*ADDENDUM NO. 1
Camp Murray – Building 5
Re-Roofing Project*

*May 26, 2016
Page 2 of 2*

ADDENDUM 1

STATE OF WASHINGTON MILITARY DEPARTMENT
 CONSTRUCTION AND FACILITIES MANAGEMENT
CAMP MURRAY - BUILDING 5
 DEMOLITION - ROOF PLAN

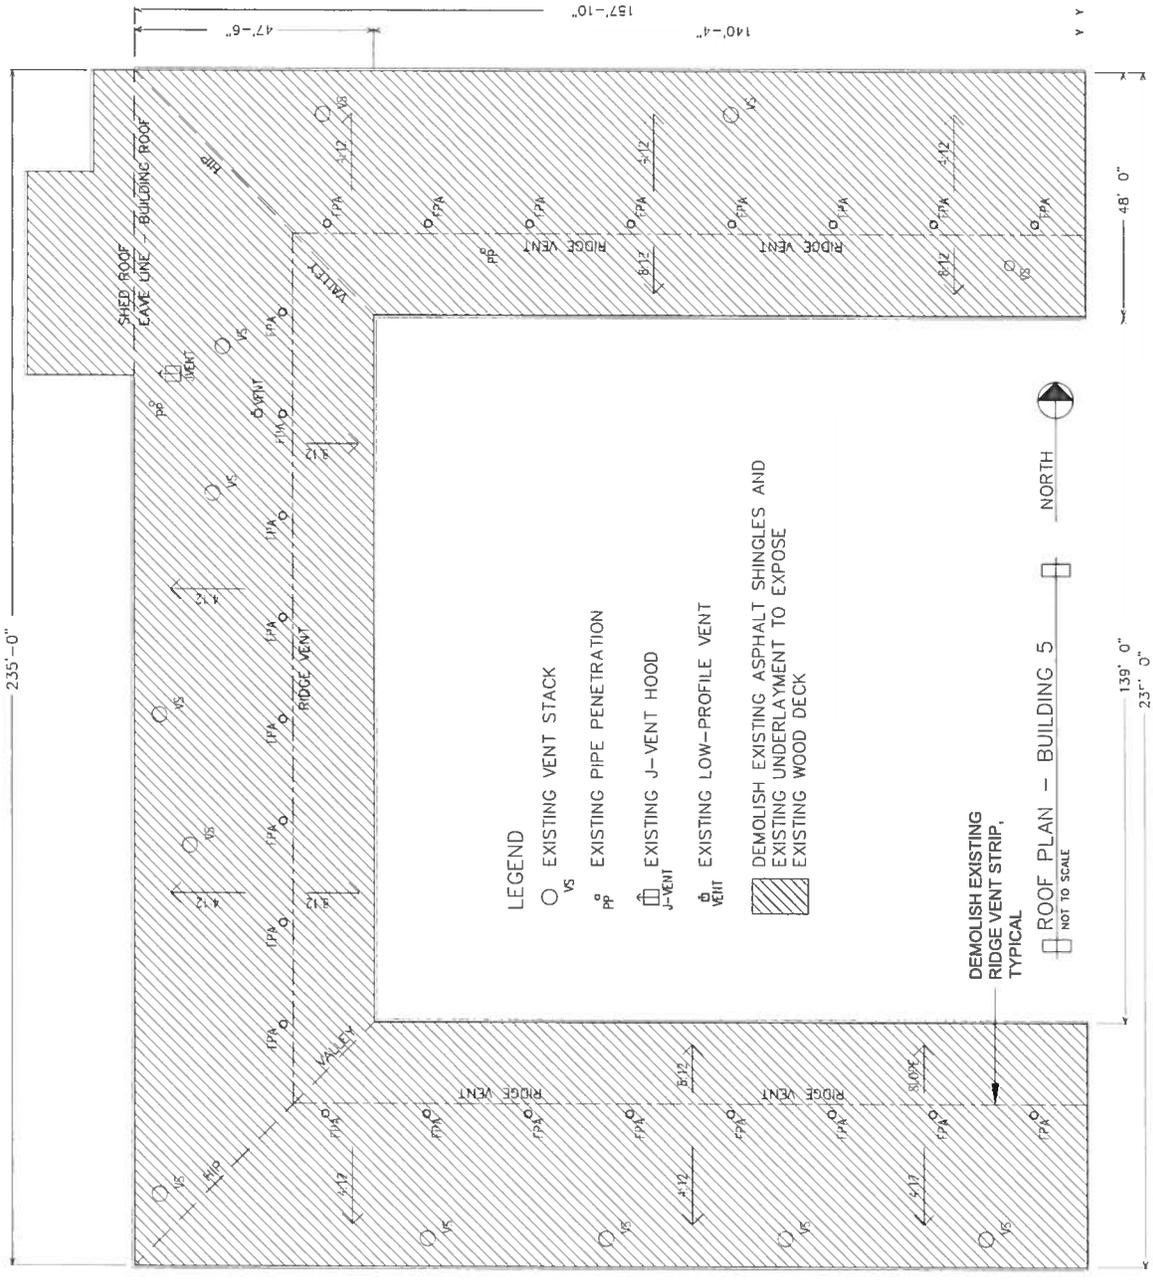
14. Use updated drawings A2 DEMO ROOF PLAN, A3 ROOF PLAN, and D3 EAVE EDGE included below.
- 15 Use updated Bid Form included below.

**CAMP MURRAY - BUILDING 5
 EAVE EDGE / GUTTER DETAIL**

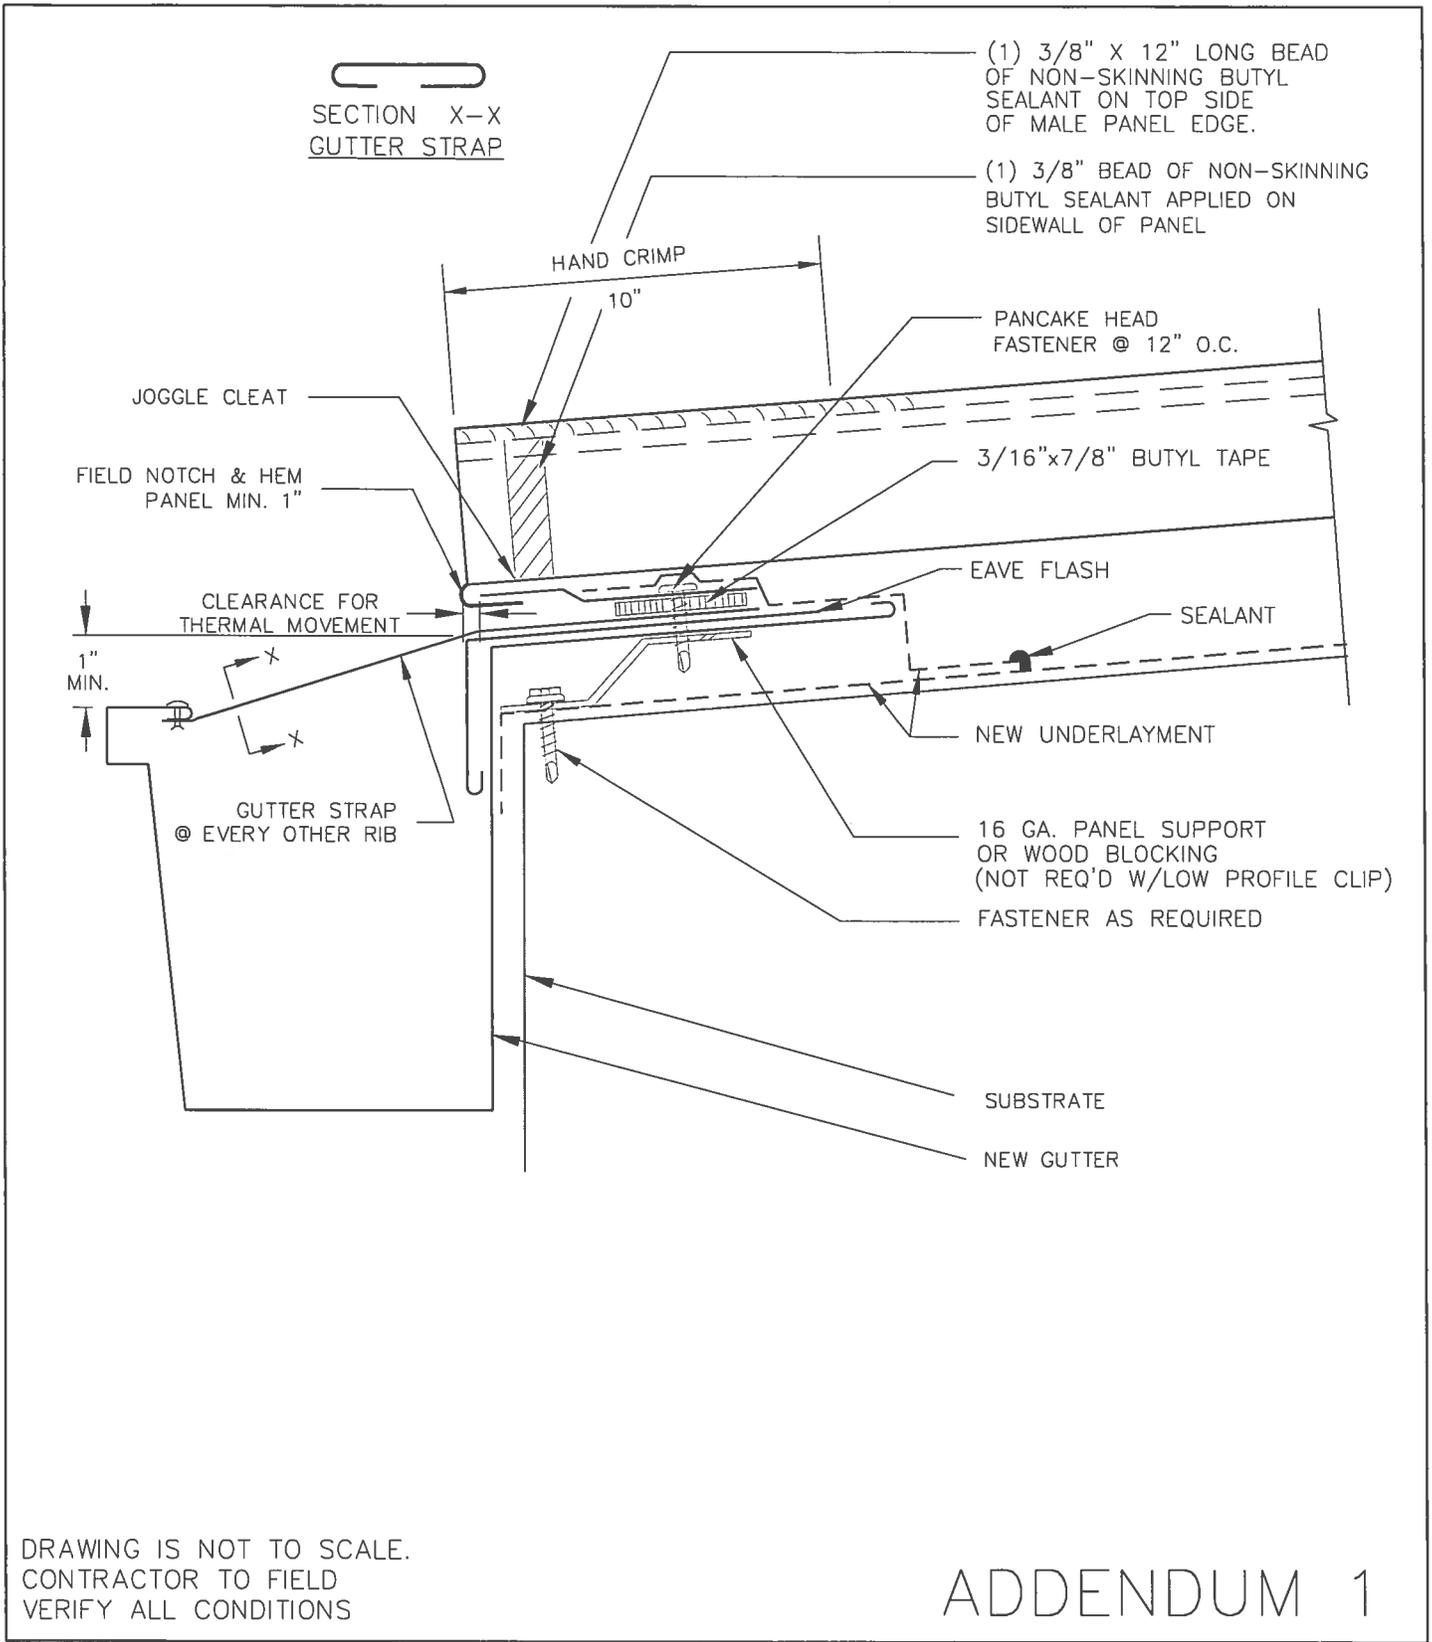
1. The Bid due date is unchanged from the advertisement – June 2, 2016 by 2:00pm
2. A copy of the NVL Laboratories report is included.
3. For gutter requirements see Specification section 076200 PART 2 H.

4. NEW: Install new downspouts. There are a total of 23 downspouts.
In specification section 076200 Part 2 add the following lines:
 - I. Downspouts: Fabricate rectangular downspouts to dimensions, complete with mitered elbows.
Furnish with metal hangers from same material as downspouts and anchors.
